First Amendment to the Draft EIR for the  
**Blossom Hill Station Mixed-Use Project**

File No.: SP20-012

June 2022

**Figure 5**  
**Existing Bicycle Facilities**

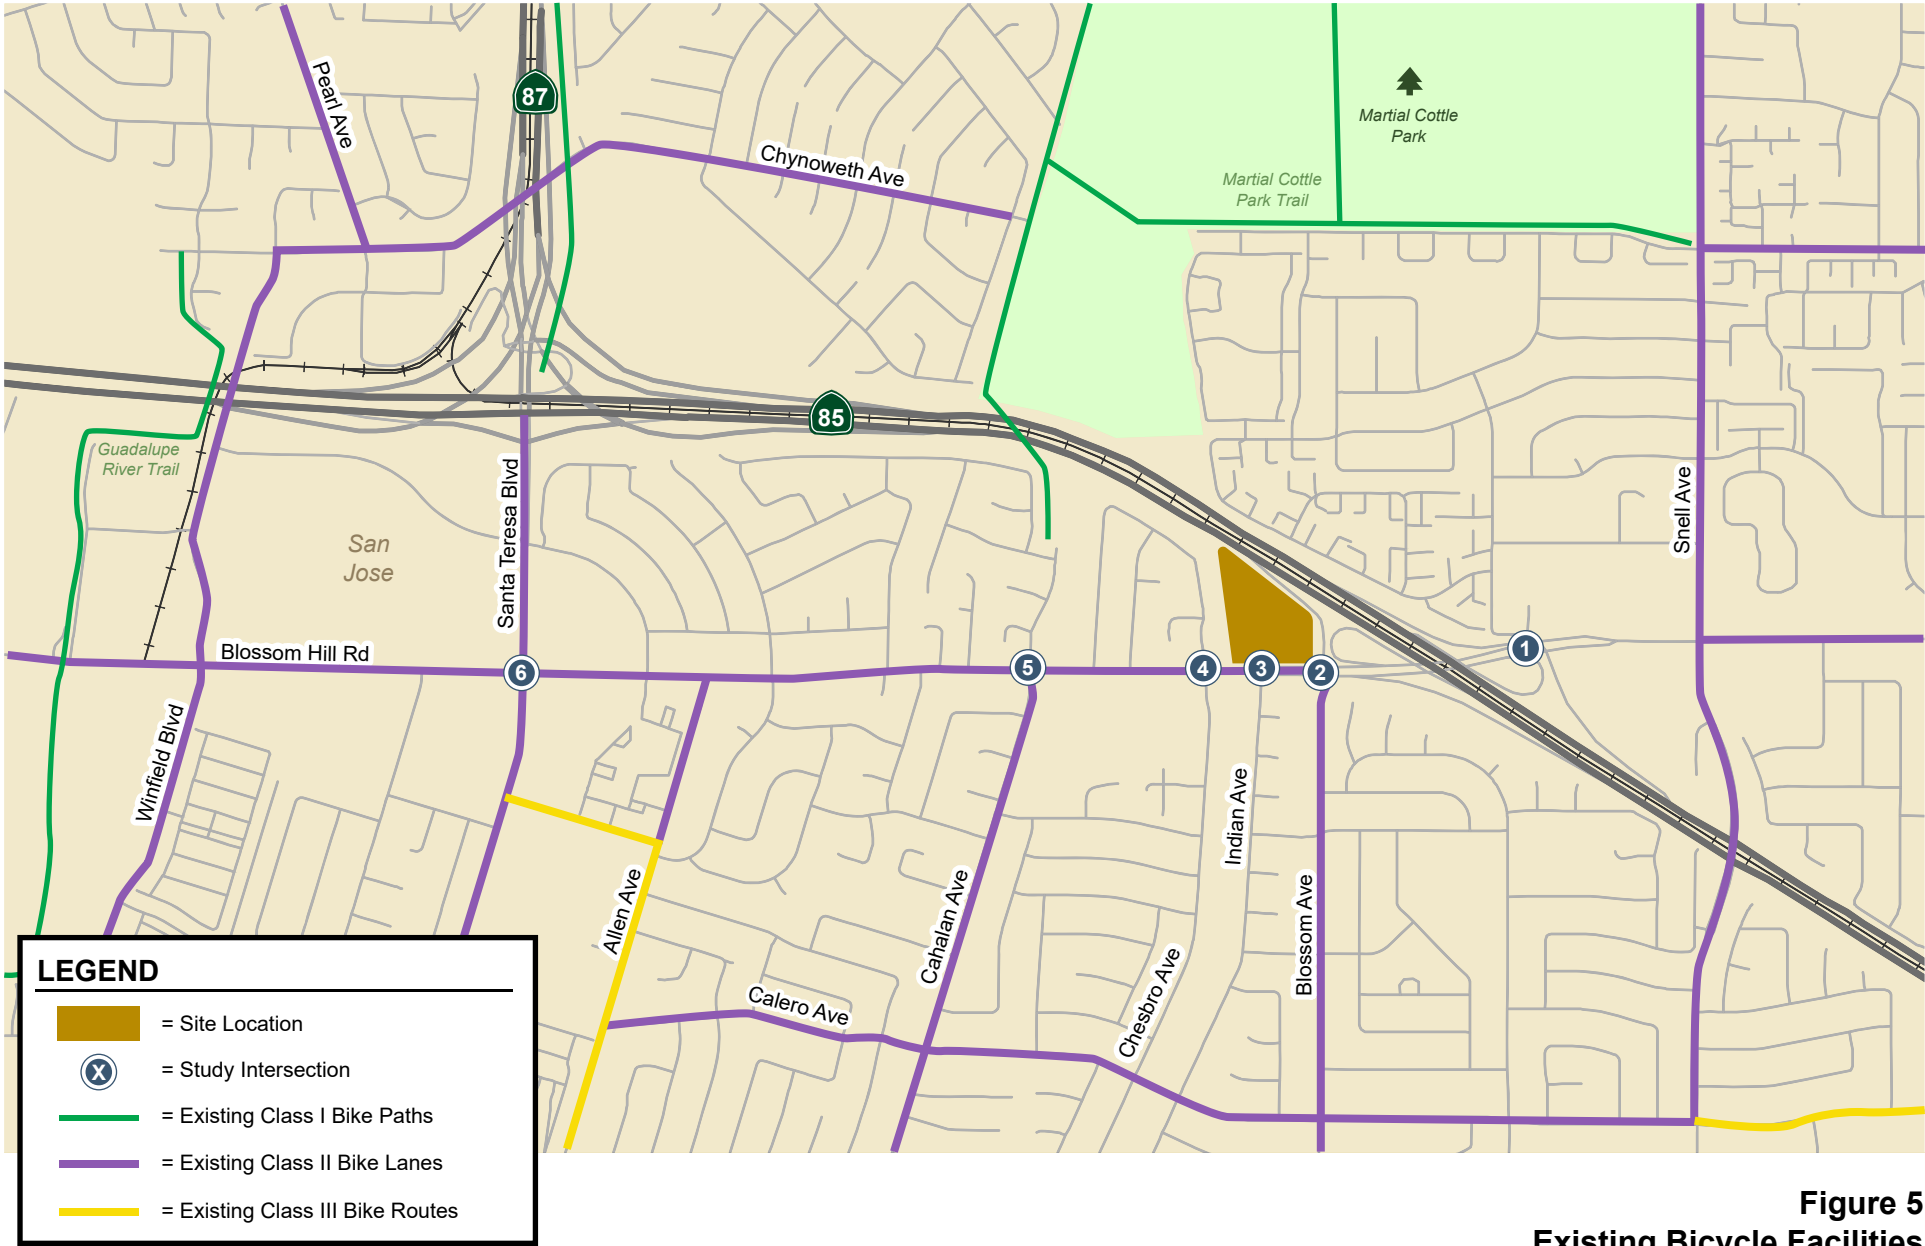
**Comment B.3: Multimodal Improvements.** 3.17.1.2 Existing Conditions, DEIR, Figure 3.17-1 and Appendix H, Transportation Impact Analysis, Figure 5. These figures only identify existing Class II Bike Lanes. Please add Class I bike paths, the 87 trail, the Guadalupe River Trail and the Martial Cottle Park Trail, consistent with the diagram on page 39 of the San Jose Better Bike Plan 2025.

3.17.1.2 *Existing Conditions, DEIR, Figure 3.17-1 and Appendix H, Transportation Impact Analysis, Figure 5.* These figures only identify existing Class II Bike Lanes. please add Class I bike paths, the 87 trail, the Guadalupe River Trail and the Martial Cottle Park Trail, consistent with the diagram on page 39 of the San Jose Better Bike Plan 2025.

**Response B.3:** This comment requests additional existing bicycle facilities be included on a figure in the Draft EIR and Appendix H to the Draft EIR. Due to the distance between the project site and the closest Class I bikeway (greater than 0.94-miles), it is unlikely that residents and employees at the project site would bike to these facilities from the project site. For these reasons, no changes to the figure are necessary. The comment does not raise any issues with the adequacy of the Draft EIR; therefore, no recirculation would be needed.
